Re: Annex Renovation

Subj: Change Proposal No. 279101-0006

We respectfully submit our proposal for an increase to our contract in the amount of \$9,726 (nine thousand seven hundred twenty-six) dollars to provide Various Electrical Changes per RFI's 5, 23, 30, 31, 32, 34 for the above referenced project.

Re: What height "D/D1" fixtures are to be intalled in this location.

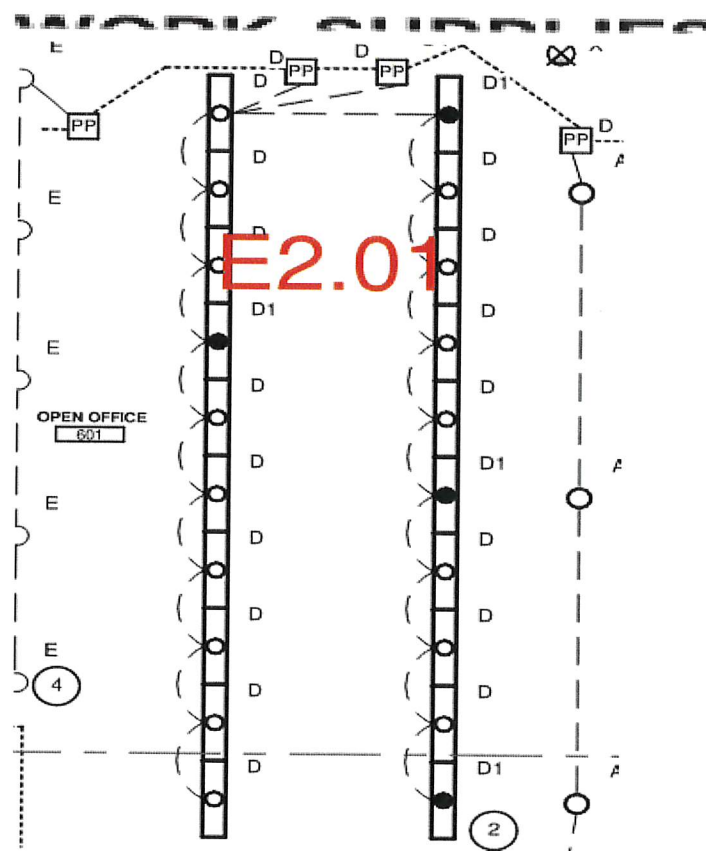
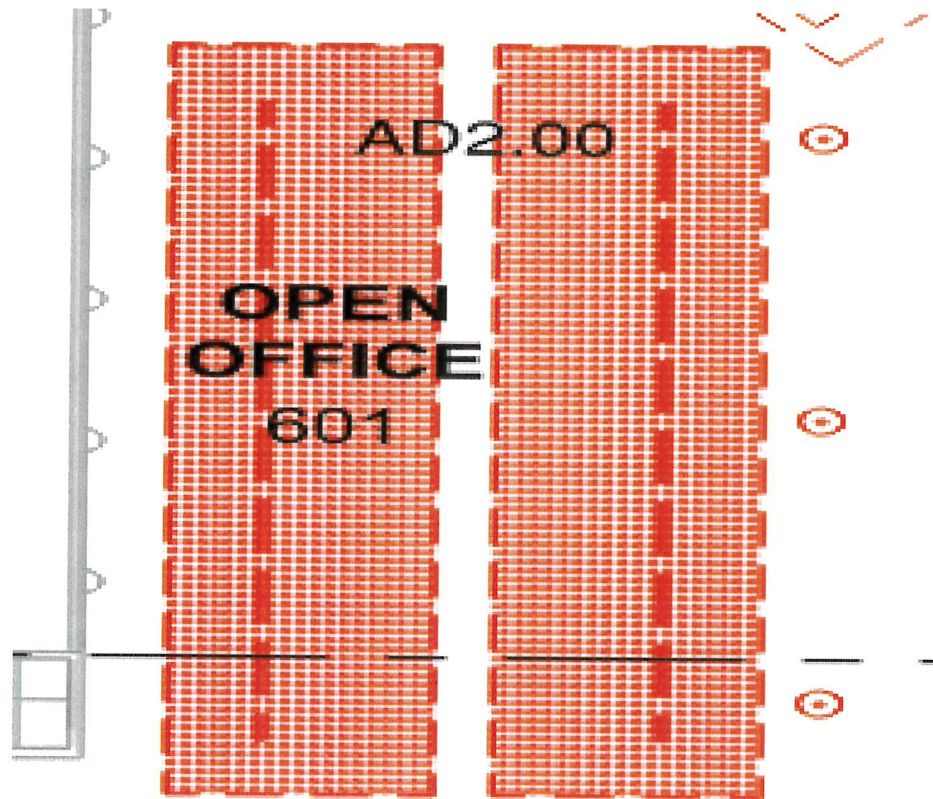
Drawing AD2.00 shows the cloud in Open Office 601 to be removed. Per drawing E2.01, "D/D1" fixtures are to be installed in this location. Please advise contractor what height "D/D1" fixtures are to be intalled in this location.

**LIGHT FIXTURES TO BE
8'-10" A.F.F.**
